0195-SD-P2-576.4-577.0-S

KEYSTONE XL PIPELINE PROJECT - STEELE CITY SEGMENT PIPELINE ROUTE VARIATION FORM			
1	VARIATION TYPE:		
	Refinement: <input type="text"/>	Reroute: <input checked="" type="checkbox"/>	
	Centerline: <input checked="" type="checkbox"/>	Valve Site: <input type="text"/>	Pump Station: <input type="text"/>
2	LOCATION:		
	Sketch: <input type="text" value="Attached"/>	Pictures: <input type="text" value="See attached."/>	
	State: <input type="text" value="SD"/>	County: <input type="text" value="Tripp"/>	Quad Map: <input type="text" value="N/A"/>
	Township: <input type="text" value="97N"/>	Range: <input type="text" value="76W"/>	Aerial Map: <input type="text" value="See attached map sheet"/>
	Section: <input type="text" value="2.1"/>	Centerline: <input type="text" value="11/18/2010"/>	MP: <input type="text" value="576.36"/> to <input type="text" value="577.01"/>
3	REASON FOR ROUTE VARIATION (Please include reason for route variation):

KEYSTONE PIPELINE PROJECT - U.S. PHASE IV (STEELE CITY SEGMENT)

KEYSTONE US - PHASE IV PIPELINE PROJECT PROPOSED ROUTE VARIATION 0195 TRIPP COUNTY, SOUTH DAKOTA					
	DATE	PROJECT	MAP PARAMETERS		
	2011-02-23	50388X	PROJECTION: UTM 14

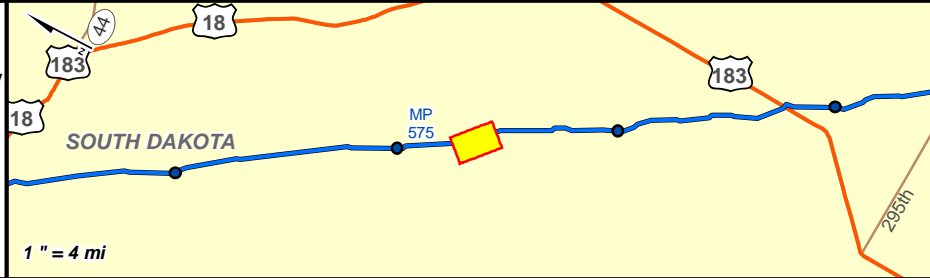
<p>This reroute is proposed to accommodate two separate requests proposed by landowners</p> <ul style="list-style-type: none"> - To avoid locating the pipeline on tract ML-SD-TR-11345. - To accommodate landowner's (John & Tammy Harter) request to avoid a row of trees near MP 576.8. <p>The approval of this reroute avoids the potential condemnation of three tracts i.e. ML-SD-TR-11345, ML-SD-TR-11340, ML-SD-TR-11360.</p>			
DETAIL ROUTE VARIATION (Please describe route variation in detail):			
<p>The proposed reroute starts at the PI near MP 576.4 and continues in the southward direction, deviating (~28°) from the centerline. It continues in this direction for ~1,200 ft until it avoids the tract ML-SD-TR-11345. It then turns towards the east and continues for ~2,420 ft to rejoin the current centerline near MP 577. Along its path, it passes through a gap in the row of trees to avoid any tree clearance as intended by the landowner. The proposed reroute also maintains sufficient distance from the Colome source water protection area.</p>

ADDITIONAL IMPACTS (Please include any additional impacts which may affect cost; crossings, induction bends, etc.):			
<p>The proposed reroute is ~202 ft longer than the original route. The approval of this proposed reroute avoids the potential condemnation of 3 landowners, the average cost of a condemnation of one landowner is estimated at ~\$30,000.</p>			
<p>Is there an increase/decrease in the number of crossings? Yes <input type="text"/> No <input checked="" type="checkbox"/></p> <p>If yes, please list: <input type="text"/></p>			
COST ANALYSIS (costs incurred or saved from the route variation)			
Additional length of route realignment:	<input type="text" value="202"/> ft.	\$ <input type="text" value="72,720.00"/>	\$ 360/ft
Additional length of side-hill construction:	<input type="text"/> ft.	\$ <input type="text" value="-"/>	\$ 19/ft
Additional length of wetland construction:	<input type="text" value="185"/> ft.	\$ <input type="text" value="36,075.00"/>	\$ 195/ft
